Suffolk County Council response to Sizewell C Non-Material Change Application Reference EN010012

Appendix A Detailed comments on the 8 Changes of the NMC application

Figure 1 Extract from ROW Sheet 2 of 28

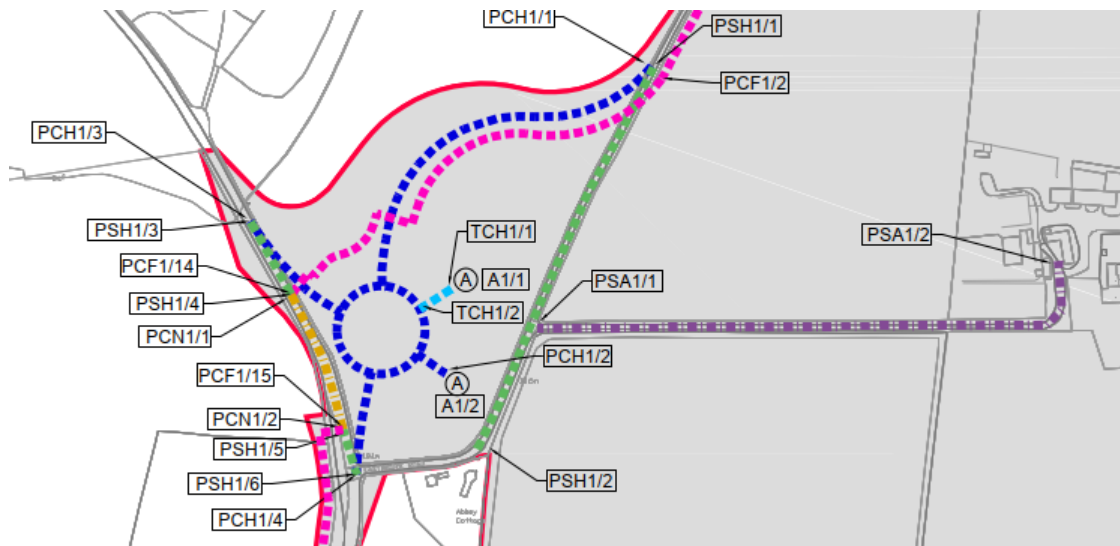
The County Council seeks assurance that the DCO points on the ROW Plans sheets 1-3 coincide with the technically approved drawings and reflect any design changes that have occurred since technical approval of the highway designs. In particular, the DCO points around the main roundabout, PCF1/14, PCF 1/15 and PCN1/1 and PCN 1/2 (Schedule 10 Part 3)

Figure 5 Extract from ROW Plan Sheet 21 of 28

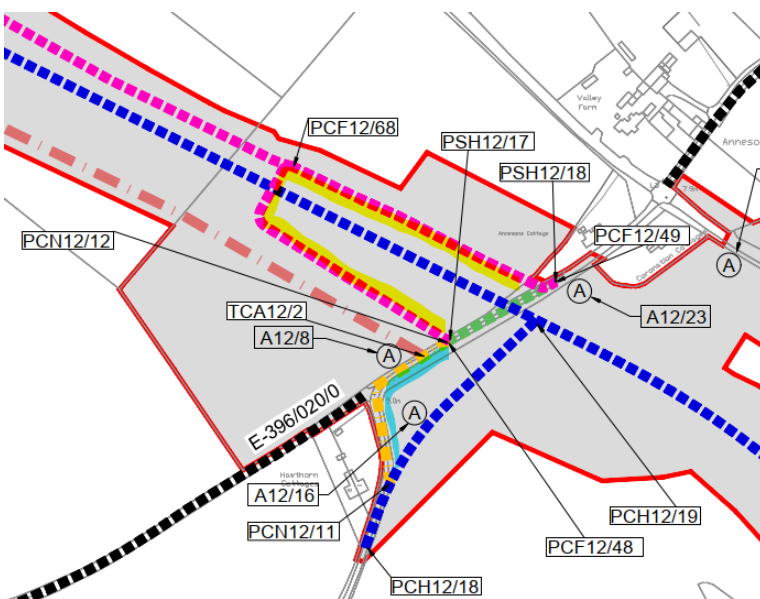
This means that equestrians and carriage drivers will have the legal right to use the NMU sections of the minor roads but no legal right to use the new routes to get across the SLR. This applies to Littlemoor Road, Hawthorn Road, Moat Road and George Road.

In Figure 5 below, the section highlighted in blue will have legal rights for NMU connecting to the substitution for the stopped up Hawthorn Road which will be footpath and cycle track, highlighted yellow.

Figure 6 Extract from ROW Plan Sheet 19 of 28

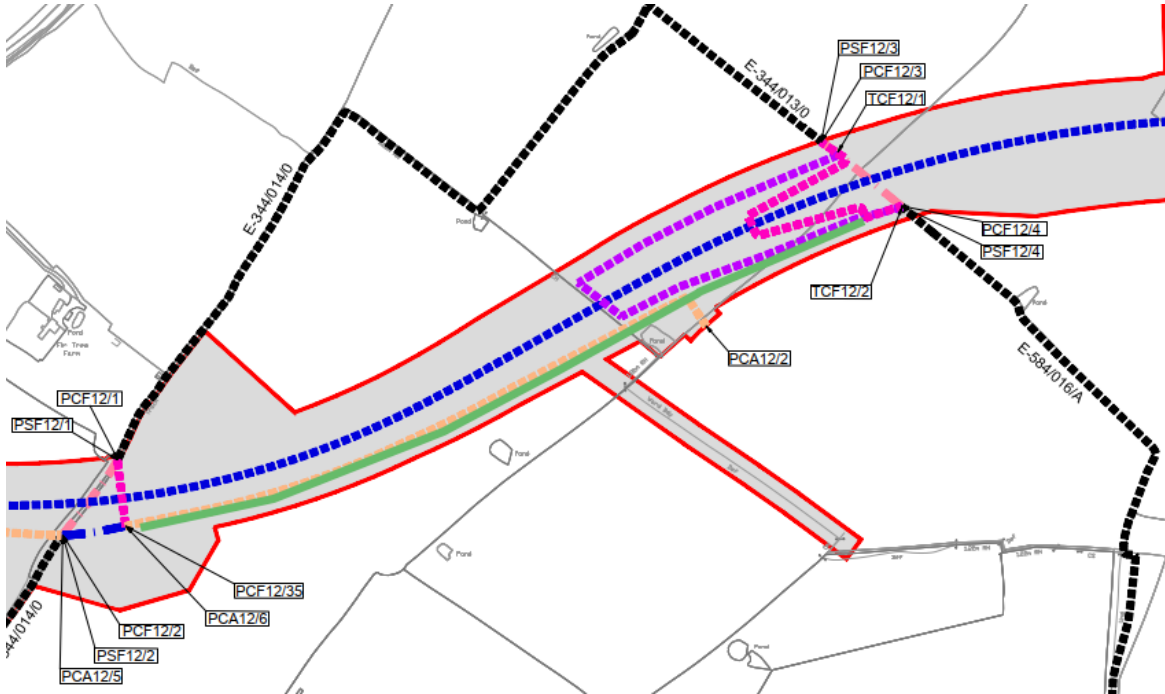
To be consistent with other ROW Plans, the access track between PCF12/35 towards PCA12/2 should be shown on the plan as a joint new permanent highway (footpath) and private means of access with the same line style as is shown between PCF12/35 and PCF12/2. East of PCA12/2, this should be depicted as new permanent highway (footpath) and be included in Schedule 11 Column (3) as footpath. The extent is indicated by the green line on Figure 6.

Figure 7 Extract of ROW Plans Sheet 20 & 21 with missing track highlighted in yellow

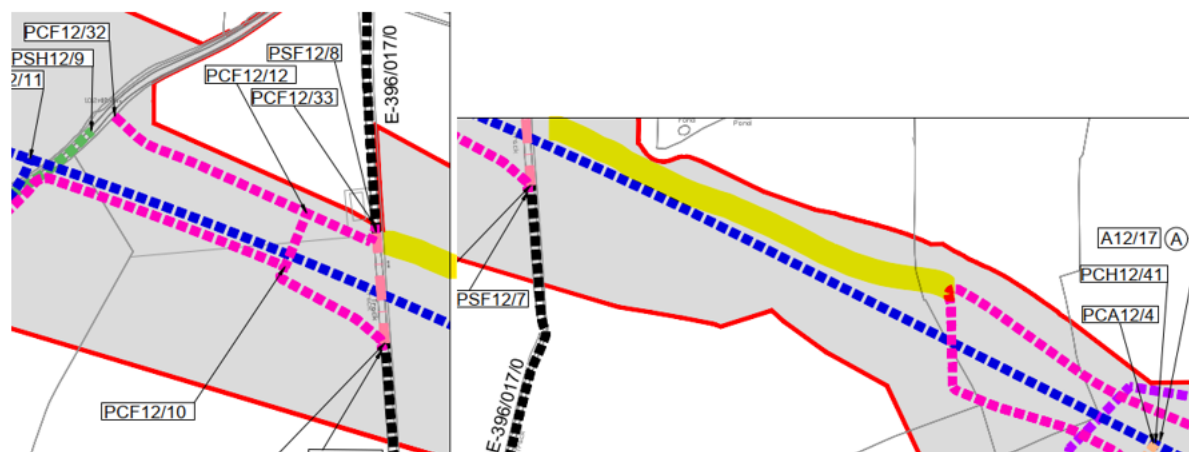
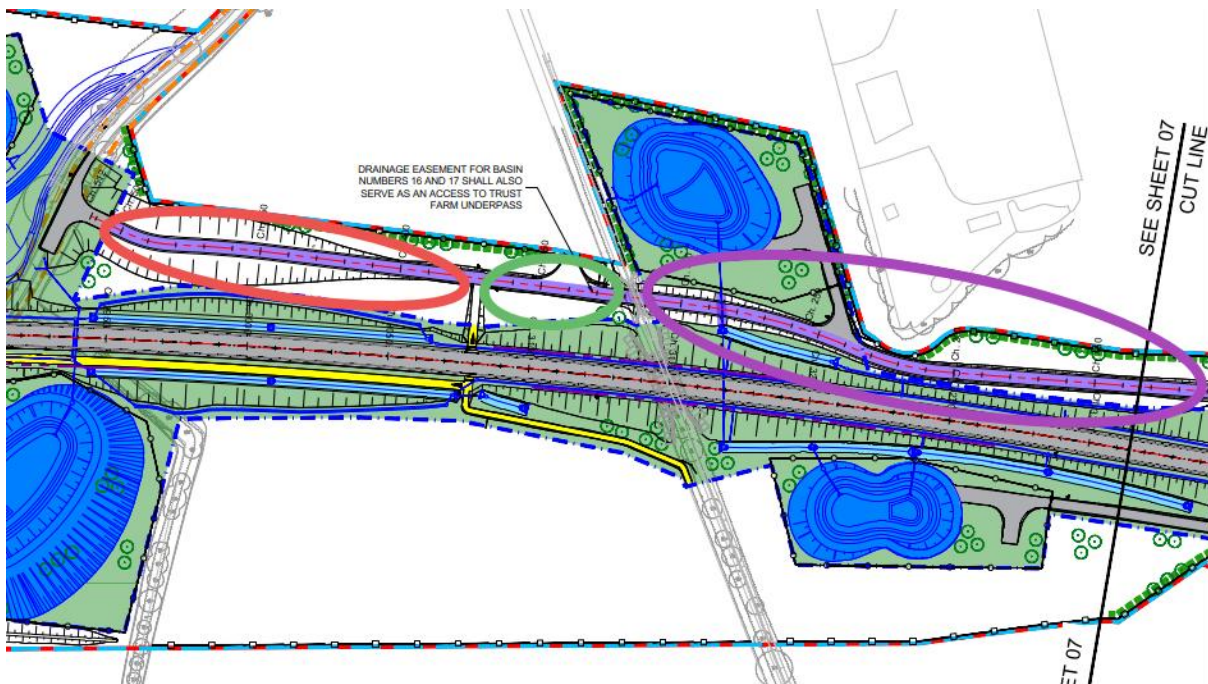
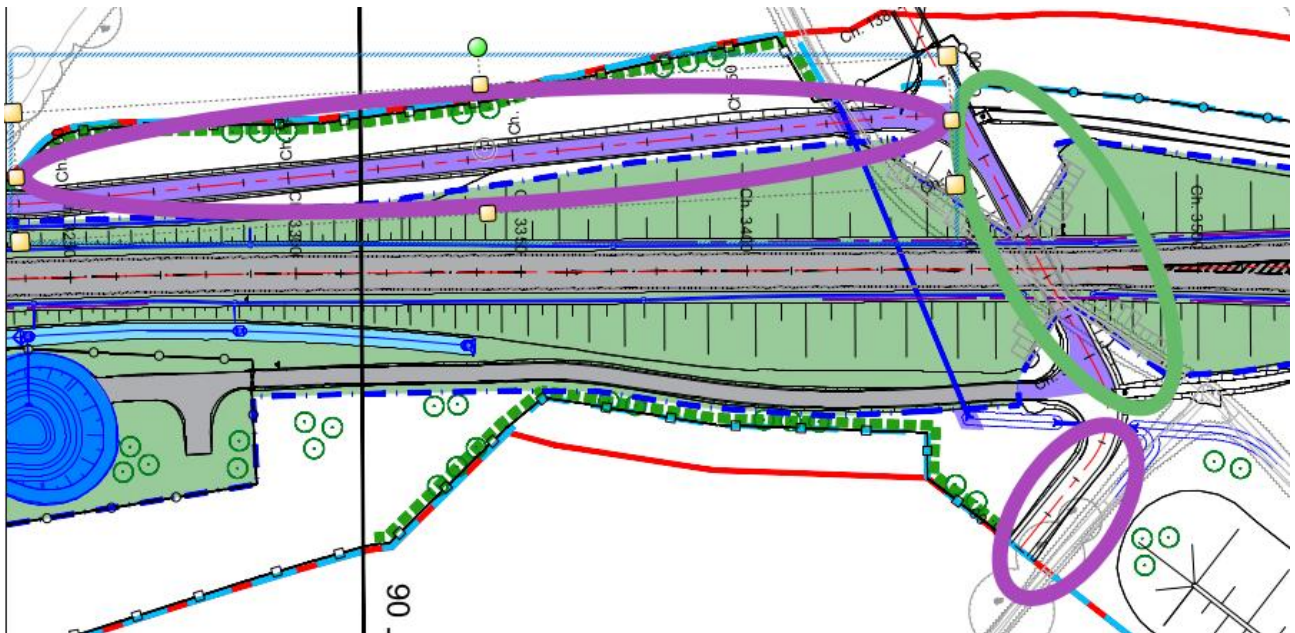
The private access track shown on the highway designs linking Fordley Road to the Trust Farm underpass is not included on the ROW Plans sheet 20 and 21, shown in Figure 7.

Is it the intention to provide this new permanent private means of access? If so, it should be included on the ROW Plans and in Schedule 12 of the DCO as is the case for other new private access tracks.

At the west end, this private access will be coincident with the NMU alternative route for Fordley Road (Figure 8 red oval), the public footpath E-396/017/0 (Figure 8 green oval) and the easement for the County Council to access the drainage basins SLR AB-16 and AB-17. The private access track (with County Council easement) then continues outside of the highway boundary to the Trust Farm underpass (Figure 8 purple oval), through the underpass shared with the alternative public footpath (Figure 8 green oval) and as a private access a short distance south of the underpass.

Figure 10 Extract from ROW Plan Sheet 21 of 28

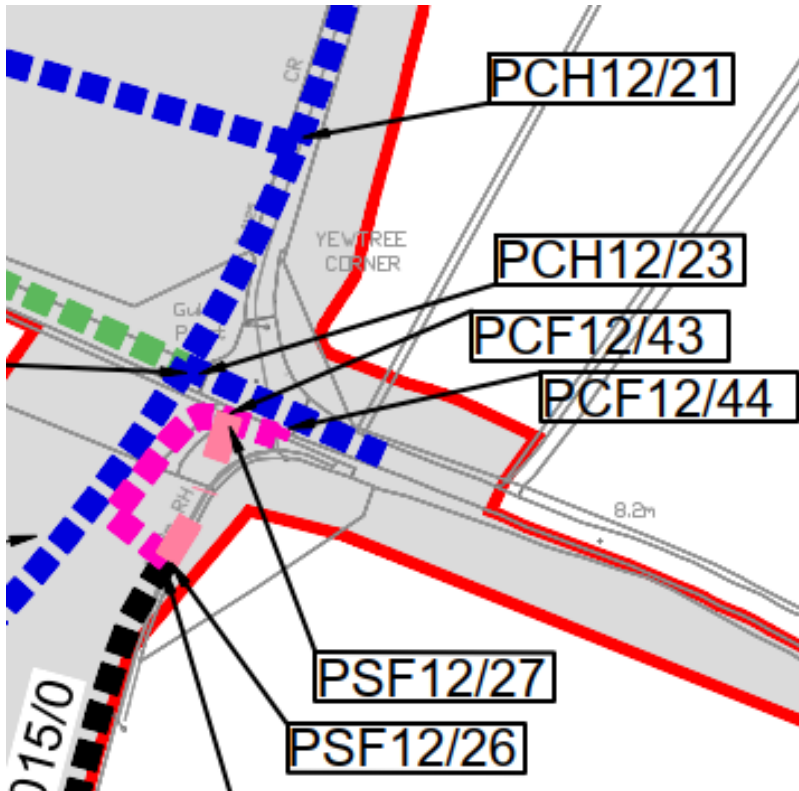
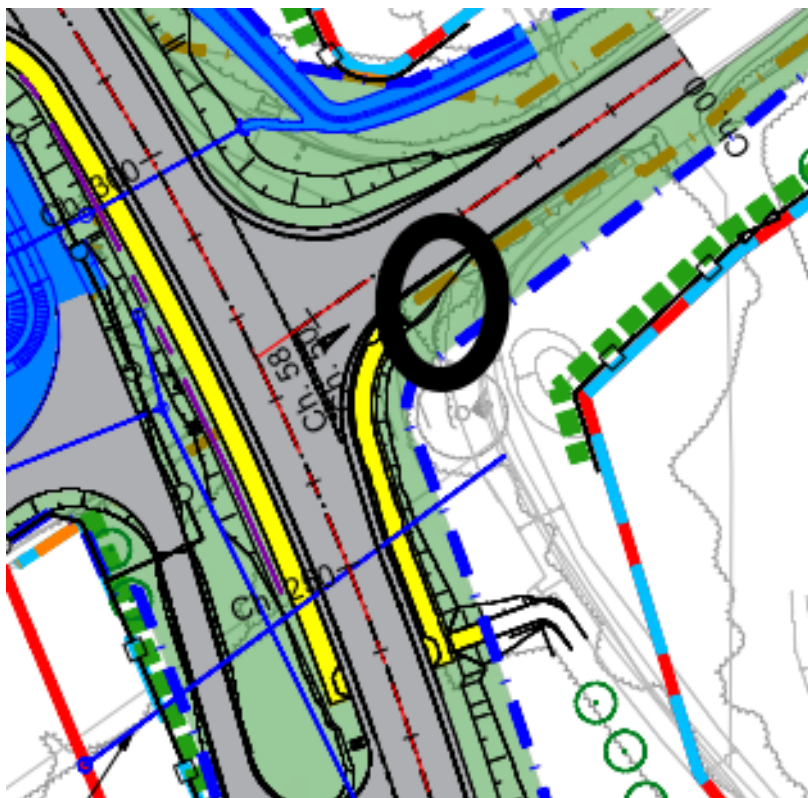
Schedule 10 Column 4 substitutes new highway (footpath) between PCF 12/42, PCF 12/43 and PCF12/44 and this is listed in Schedule 11 Column (3) as footpath. However, this will result in new

footpath created on a tapering section of verge which is unusable and not satisfactory. This is shown in the black circle on Figure 11.

The County Council request that PCF12/44 is removed from ROW Plan sheet 21 and omitted from Schedule 10 Column (4) and Schedule 11 Column (3).

Figure 12 Extract from ROW Plan Sheet 22 of 28

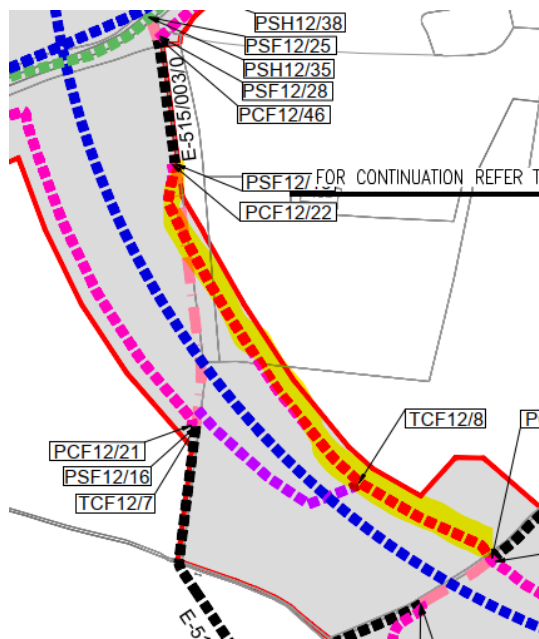
Schedule 10 Column 4 should include the section from PCF12/22 to PCF12/23 as highlighted in yellow in Figure 12 ROW Plan Sheet 22.

Figure 13 Extract from ROW Plan Sheet 21 of 28

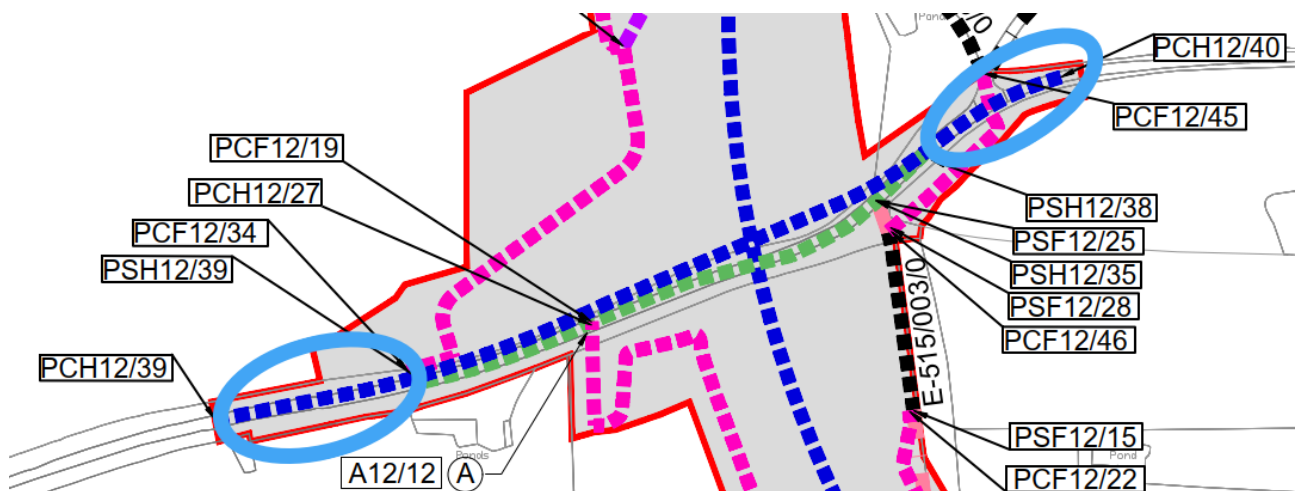
The extent of stopped up road is shorter than the new road to be substituted. For accuracy, the County Council suggest that PCH12/39 and PSH12/39 point to the same location and likewise PCH12/40 and PSH12/38. These sections circled below in blue on Figure 13.

Figure 15 Extract from ROW Plan Sheet 21 of 28

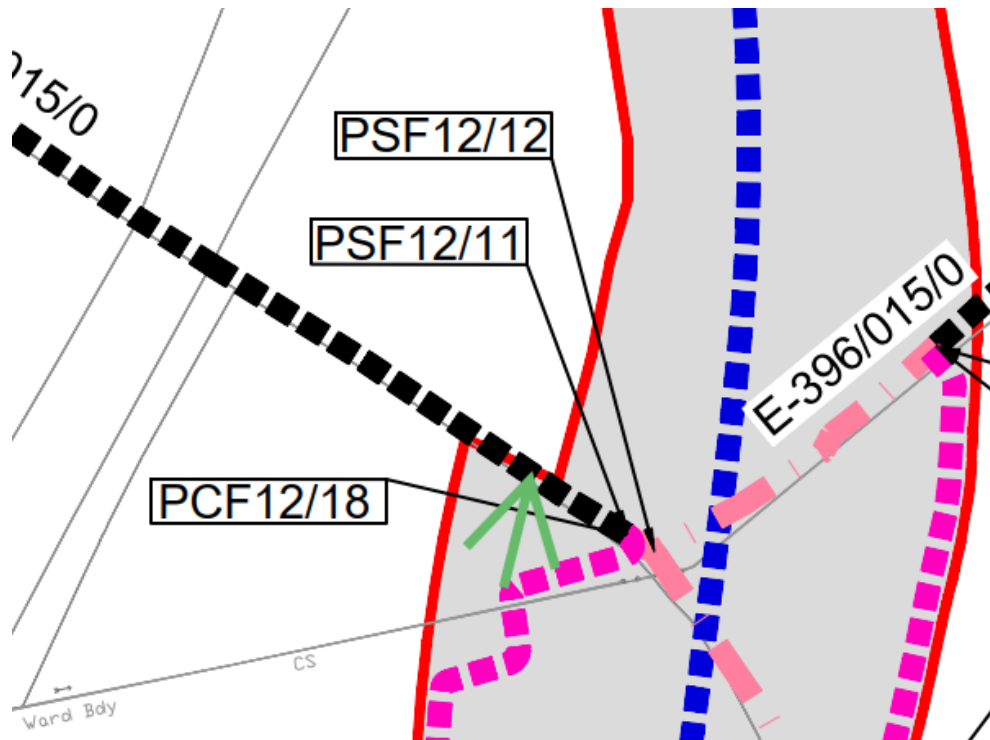
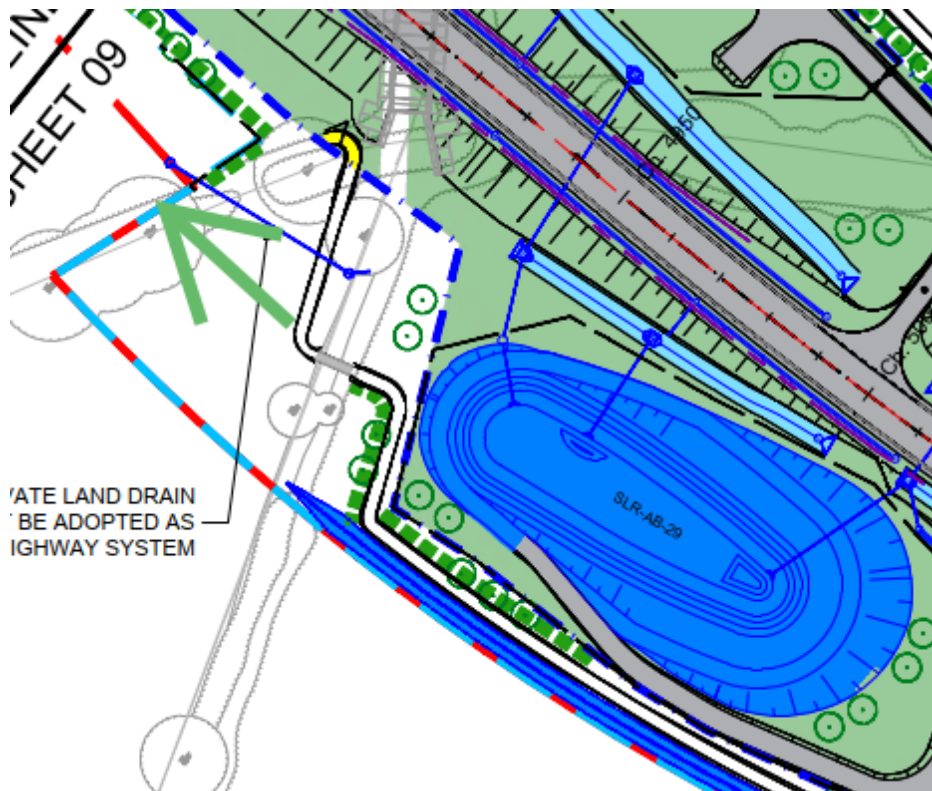
The County Council requests that the DCO point PSF12/11 and corresponding point PCF12/18 are moved as indicated on Figure 15 by the green arrow, to enable a more intuitive design for the substituted footpath around the basin SLR AB-29 and to be further away from the wingwalls of the under-road culvert, shown in Figure 16.

Figure 17 Extract from ROW Plan Sheet 22 of 28

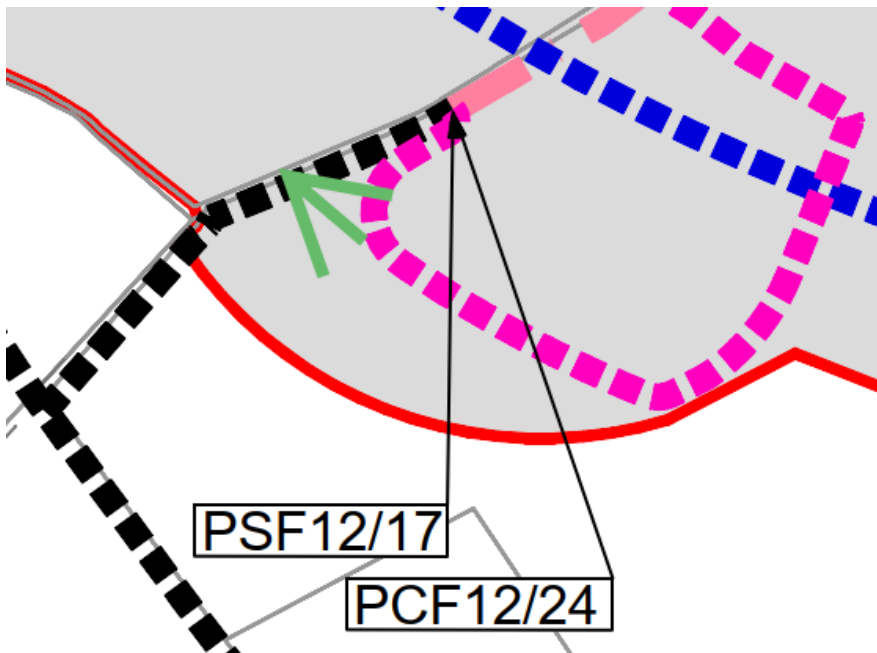
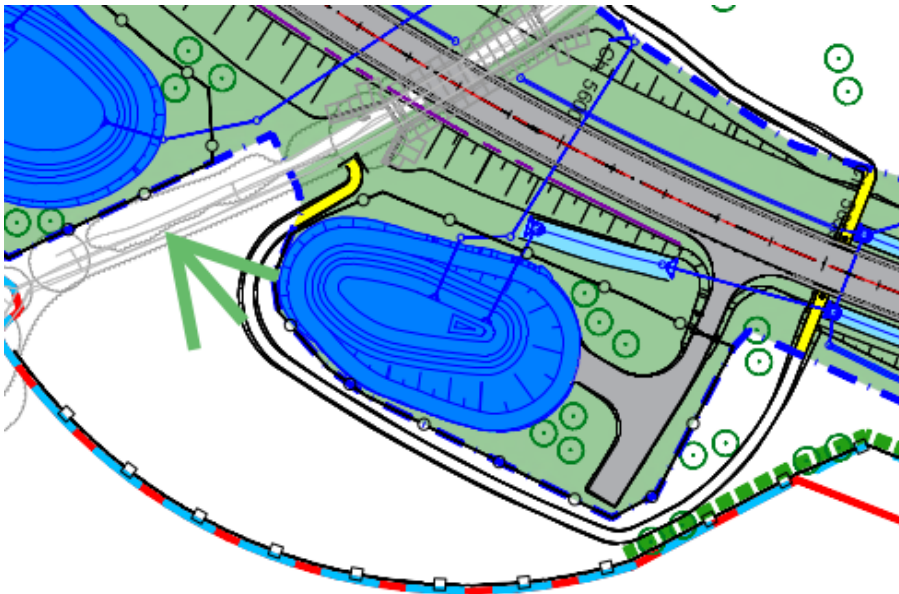
The County Council requests that the DCO points PSF12/17 and corresponding point PCF12/24 are moved south-west as indicated on Figure 17 by the green arrow to enable a more intuitive design for the substituted footpath around the basin SLR AB-34 and to be further away from the wingwalls of the under-road culvert, as shown in Figure 18.

Figure 19 Extract from ROW Plan Sheet 22 of 28

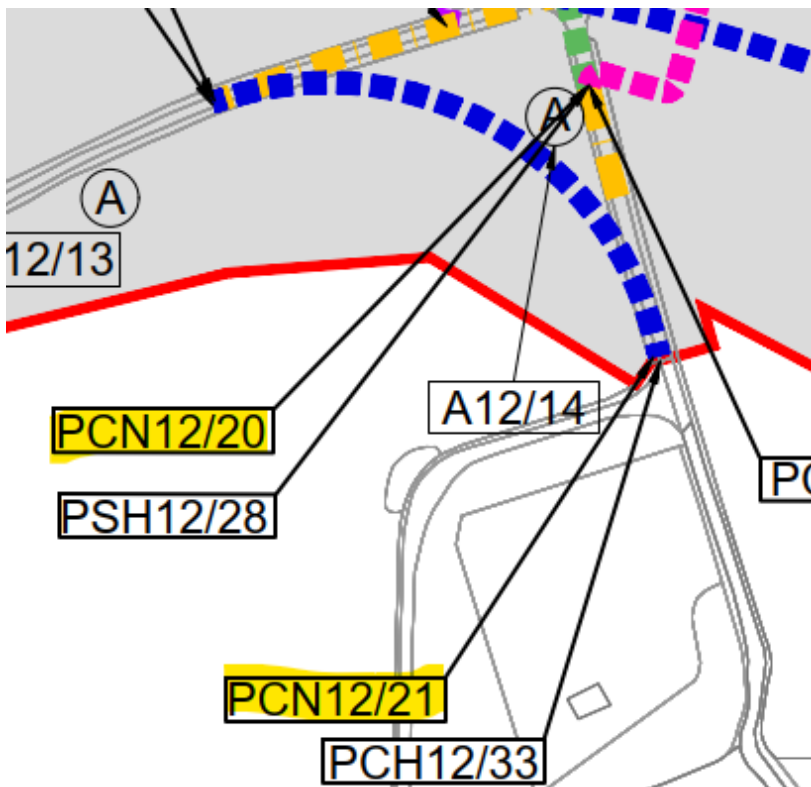
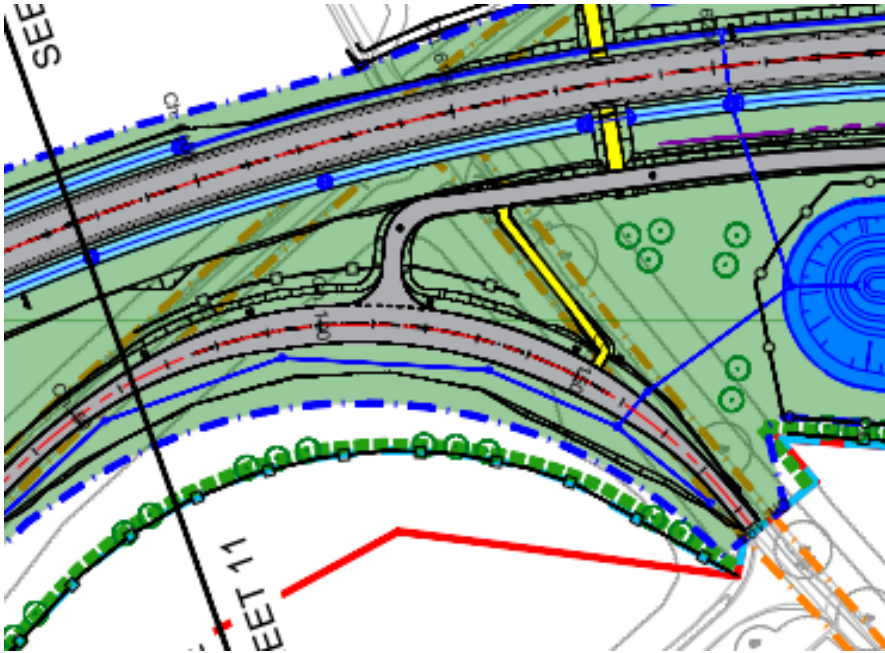
Schedule 10 Part 1 Moat Road, Column 3 - PSH 12/24 is not shown on the ROW plans and does not appear to be needed and could be omitted from Schedule 10.

Schedule 10 Part 3 PCN12/18 to PCN12/19 is created as highway NMU but PCN12/19 is not shown on the ROW Plan sheet 22.

Schedule 10 Part 3 & Sheet 22 - PCN12/22 and PCN12/23 point at the same location on ROW Plan sheet 22 but are listed as new highway for NMU in Schedule 10. This does not seem correct.

ROW Sheet 22 - Schedule 10 Part 3 changes a section of unnamed road (George Road) from vehicular traffic to NMU (from PCN 12/20 to PCN 12/21). However, compared to the highway drawing, it appears that the position of point PCN12/21 is too far south on George Road and would result in vehicle rights traffic being stopped up on a section required for vehicles.
